**CITY OF LA CROSSE, WISCONSIN
CITY PLAN COMMISSION
REPORT
March 2, 2020**

➤ **AGENDA ITEM – 20-0325 (Andrea Schnick)**

Review of Plans at a portion of Lot 27, Berlin Drive, in the International Business Park (Scannell Properties/FedEx Ground).

DRAWN BY: [] DESIGNER: [] CHECKED BY: [] DESIGN TEAM: []	REVISIONS: [] NO. BY: [] DATE: []	LA CROSSE DISTRIBUTION CENTER LA CROSSE, WISCONSIN	PRELIMINARY SITE PLAN	FILE NO. 146296	1
---	--	---	-----------------------	--------------------	---

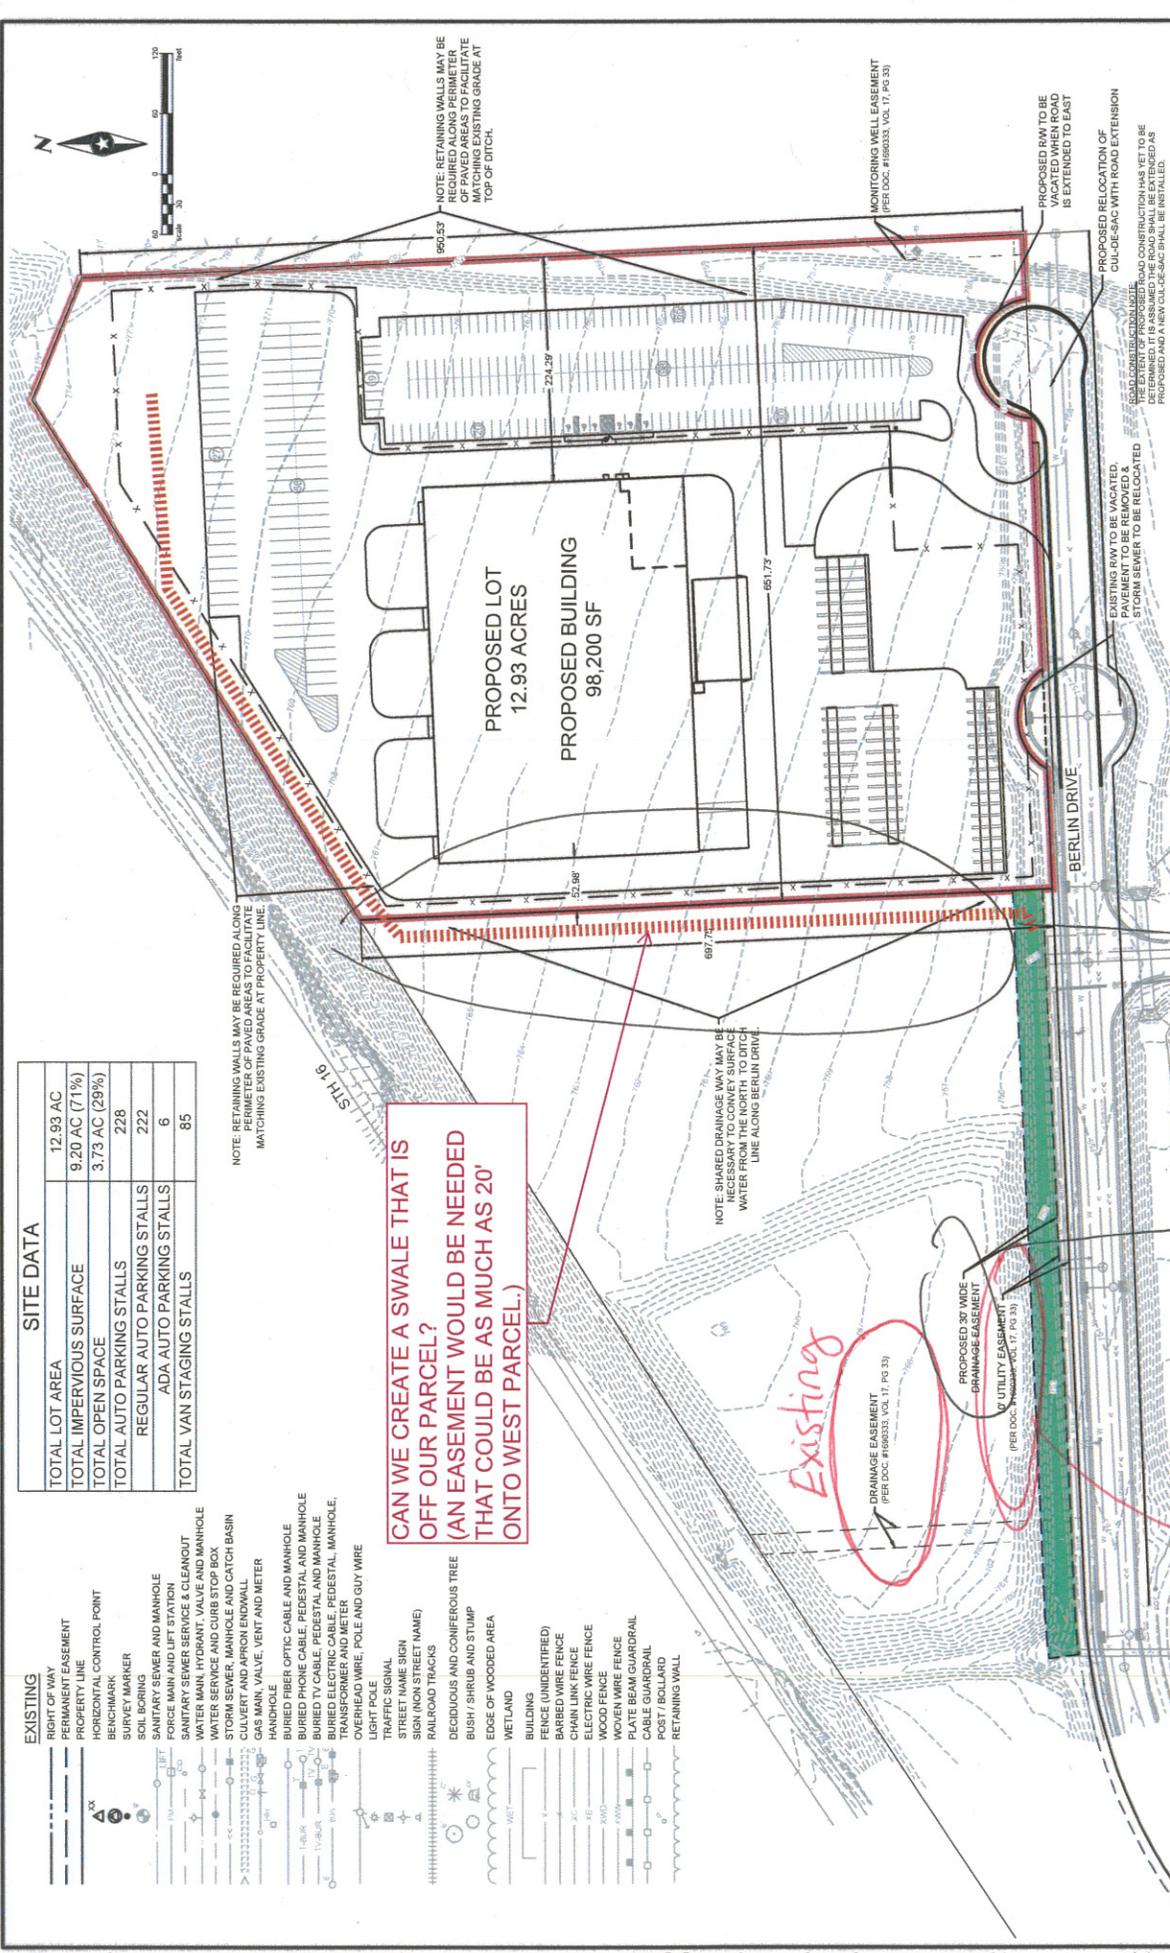
The developer has encountered an issue with the drainage system and is requesting an easement from the City to allow permanent use of the drainage ditch that was designed to be temporary. Lot 27 was designed by the City to be one parcel, and with it being split into two, imposes an issue of connecting to the drainage area at the west of the full site.

They have also requested a North-South swale easement to be approved similar to the above requested easement.

CAN WE CREATE A SWALE THAT IS OFF OUR PARCEL? (AN EASEMENT WOULD BE NEEDED THAT COULD BE AS MUCH AS 20' ONTO WEST PARCEL.)

NOTE: SHARED DRAINAGE MAY BE REQUIRED TO REMOVE WATER FROM THE NORTH TO DITCH LINE ALONG BERLIN DRIVE.

If the City agrees to the easements, they should be drafted by the developer, approved by Engineering and Utilities, and have maintenance and cost as the responsibility of the developer.

Planning staff approves subject to Engineering and Utilities approval of moving forward with the negotiation for the easements.
